HOLDOVER

SPRINGHILL PLACE SUBDIVISION

APPLICATION NUMBER Holdover DATE October 20, 2005

DETAIL SITE PLAN

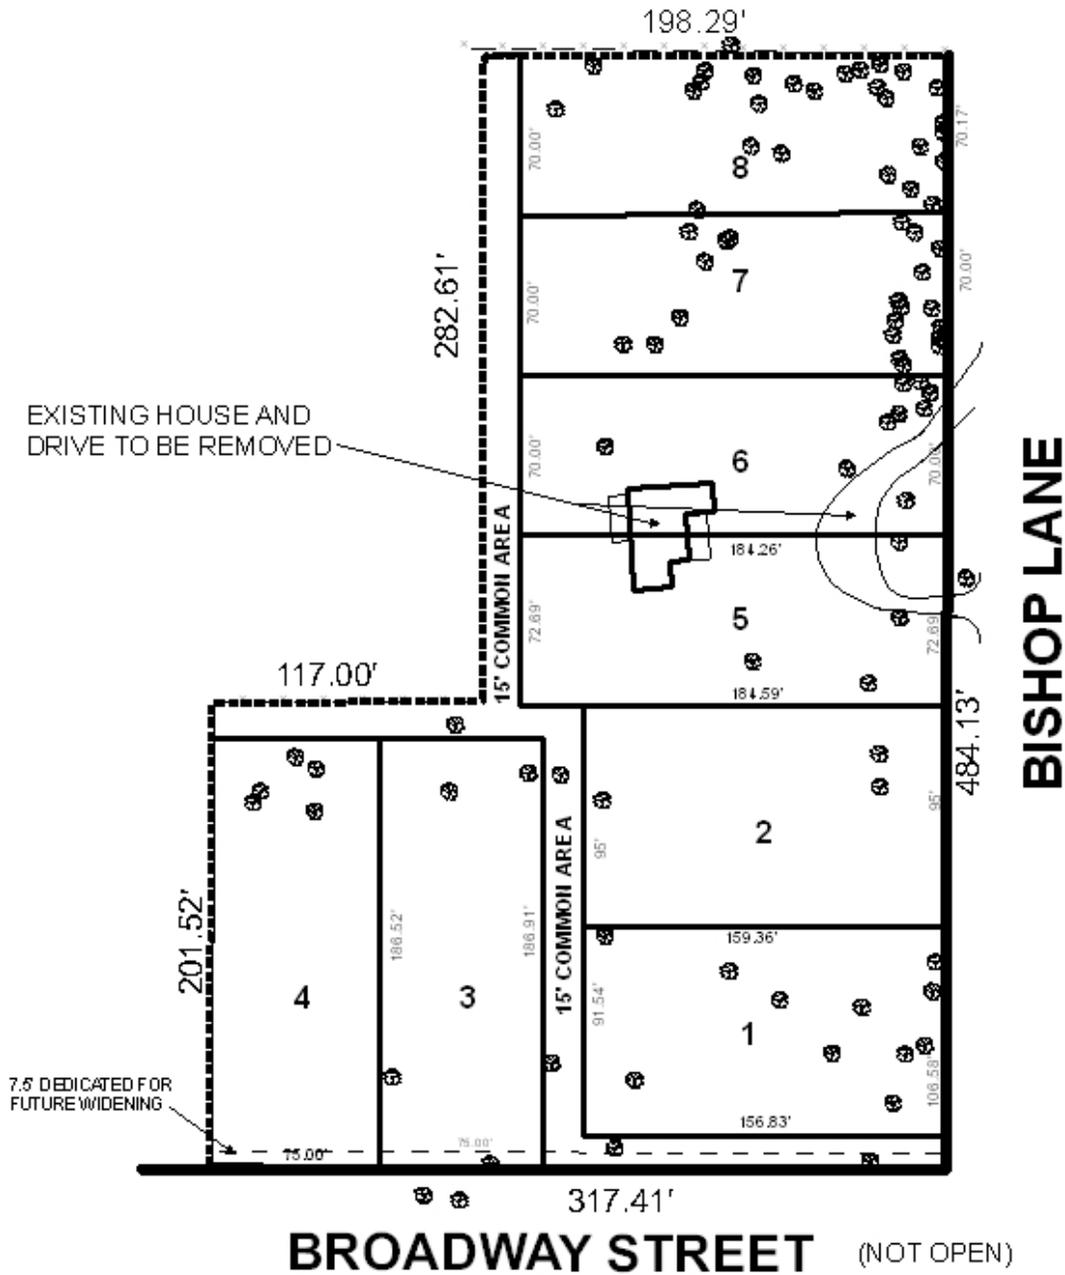
Engineering Comments: Stormwater detention and Common Area for such not shown on preliminary plat. Stormwater detention is required for this site and must be constructed within a Common Area prior to approval of the final plat. Must comply with all stormwater and flood control ordinances. Any work performed in the right of way will require a right of way permit.

The site fronts Bishop Lane, which has a 50-foot right-of-way, and an unopened right-of-way for Broadway Street, which ranges from approximately 35 to 40 feet in width adjacent to the site. The plat illustrates dedication of 7.5 feet for future construction of Broadway Street. The plat does not show the 25-foot building setback lines, which would be required on the final plat.

Proposed Lots 3 and 4 are shown as flag-shaped lots. Section V.D.1. of the Subdivision Regulations, states: "*The size, width, depth, shape, and orientation of lots and the minimum building setbacks lines shall be appropriate to the location of the subdivision and the type of development and use contemplated.*" It is not clear that such lots would be appropriate for this location; while there is a large parcel to the West of the site that is flag-shaped, such lots are uncharacteristic of the area in general. It should be noted that approval of this request could encourage future requests for subdivisions with flag-shaped lots.

The orientation of the houses on proposed Lots 3 and 4 poses further concerns, as they would essentially be double-frontage lots. Double-frontage lots are generally prohibited by Section V.D.8, except "*where necessary to provide separation of residential development from major streets or to overcome specific disadvantages of topography and orientation.*" Furthermore, the plat poses issues of orientation, which Section V.D.1 of the Subdivision Regulations (cited in the previous paragraph) also addresses. For the house to be oriented toward an unopened right-of-way would be undesirable; yet, in the event of Broadway Street's construction, for the rear of the

As noted by Engineering, detention is required but not shown on the plat; detention must be provided in a common area, to comply with all stormwater and flood control ordinances, and to be maintained by the property owners.

The applicant has submitted a revised plat illustrating an eight-lot subdivision with six lots fronting Bishop Lane, and two fronting the City-maintained portion of Broadway Street. The plat also illustrates a continuous 15-foot wide strip of common area that borders the rear of all lots, as well as the unopened portion of Broadway Street; a note will be required on the final plat stating that maintenance of common areas will be the responsibility of the property owners. The applicant's engineer has explained that this strip will be planted, and will include underground detention; City Engineering comments that they have not been contacted by the applicant's engineer about detention; that due to the high failure rate of underground detention, the City is not in the practice of accepting it; and that the detention area does not appear large enough to be satisfactory.

The plat does not show the required 25-foot setback from the right-of-way, which would be required on the final plat, but it does show a 7.5-foot dedication along Broadway Street. It should be noted that this dedication would halve the portion of the common area adjoining Broadway Street.

Based on the preceding, this application is recommended for Holdover to allow the applicant to redesign the plat without flag-shaped lots and with detention and common areas shown.

Based on the preceding, it is recommended that this application be denied.
